**RE: 4-6 Bligh Street, Sydney
 Planning Proposal Addendum**

This letter is intended as an addendum to the Planning Proposal which was considered as part of the Rezoning Review process and is intended to address the concerns of Council as raised in the email from Andrew Thomas, A/ Director City Planning, Development & Transport, dated 22 January 2018 (**Attachment A**), and the corresponding meeting held between the applicant and City of Sydney staff on 30 January 2018 (Meeting minutes provided at **Attachment B**).

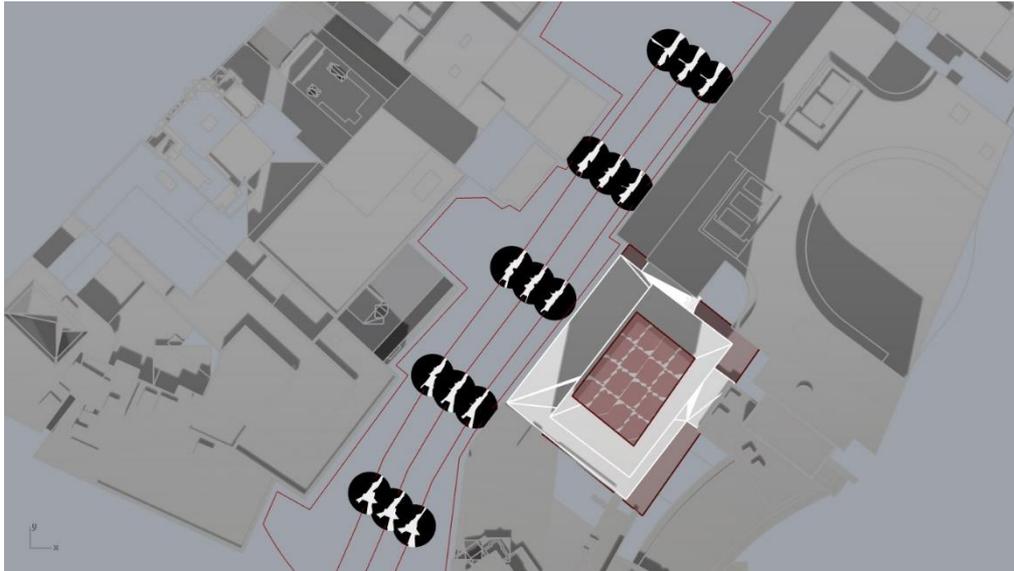
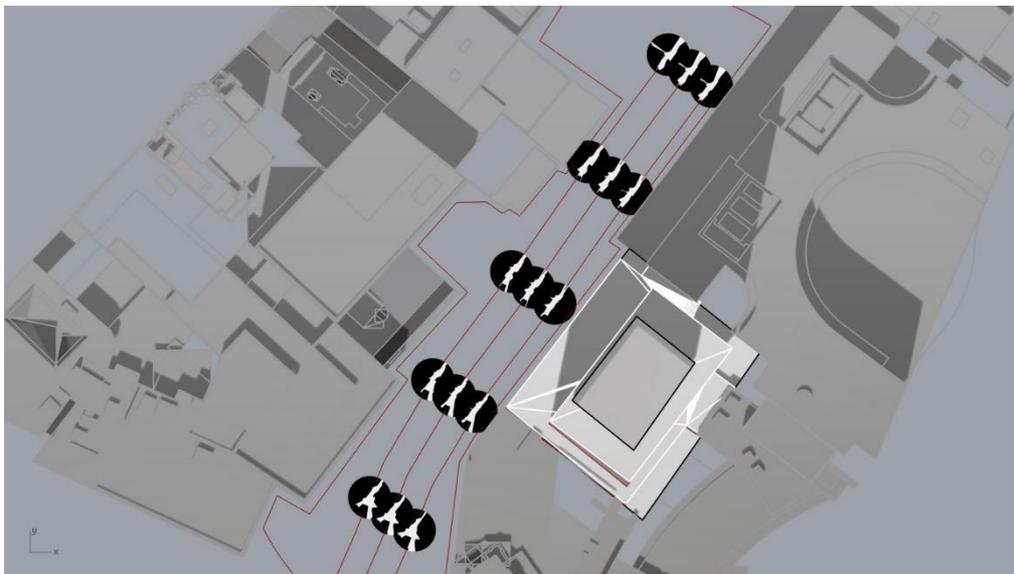
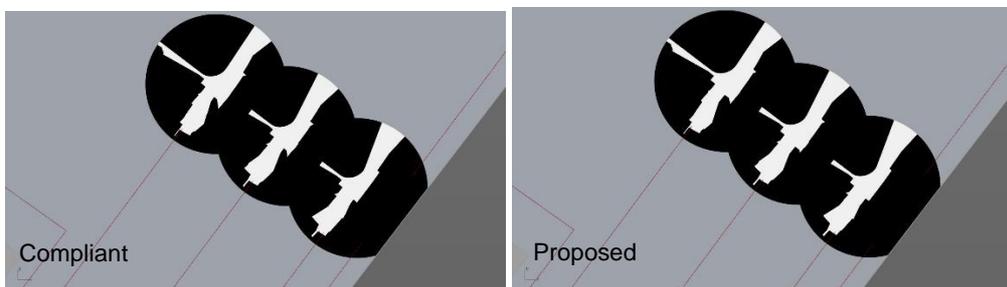
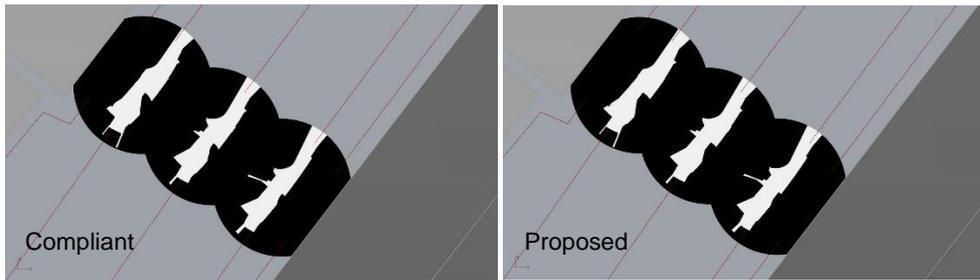
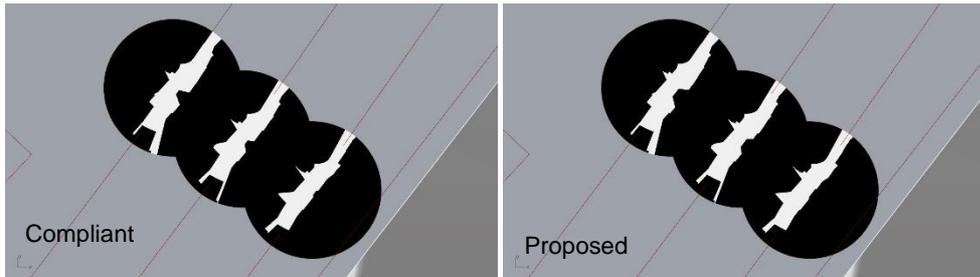
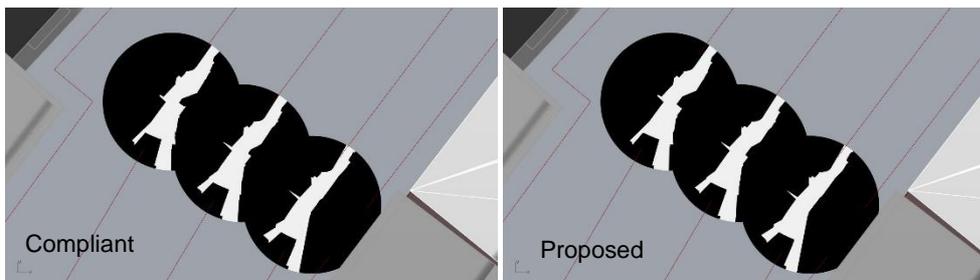
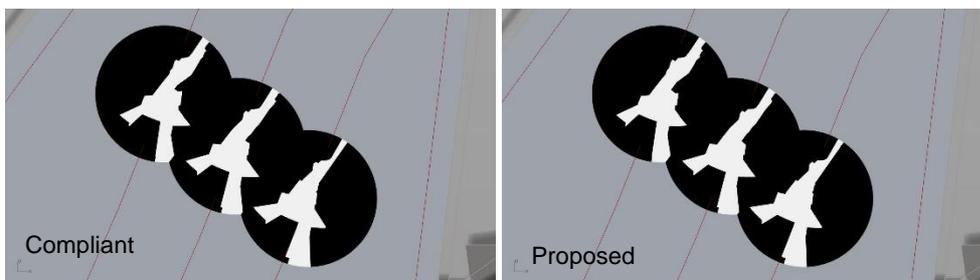
Council had identified that the raster images prepared for the SVF Report were of a low resolution and queried whether a higher resolution analysis would achieve different results. It is noted that the analysis was initially undertaken as a low resolution due to the high volume of analysis points required (3,151) to satisfy Council's proposed methodology. Additional analysis was undertaken at a far higher resolution at 15 locations within Bligh Street as illustrated in Figure 1 and Figure 2 below. The SVF views produced for the compliant and proposed building envelopes at an increased image resolution are provided in Figures 3 to 7 below.

The SVF results for the 15 analysis points at both a high and low resolution are provided in Table 1 and Table 2 below.

Using only the 15 analysis points detailed in this letter, Option 1 (reduced tower height) was again tested to assess the reduction in building height required and whether the resolution of the raster images influenced the results. The results are as follows:

Low resolution: Maximum building height 151 m

High resolution: Maximum building height 144 m

While the above results clearly indicate that the resolution of the raster image affects the results of the analysis, the impact on the proposed development are similarly considered to be major and would have a critical impact on project viability.
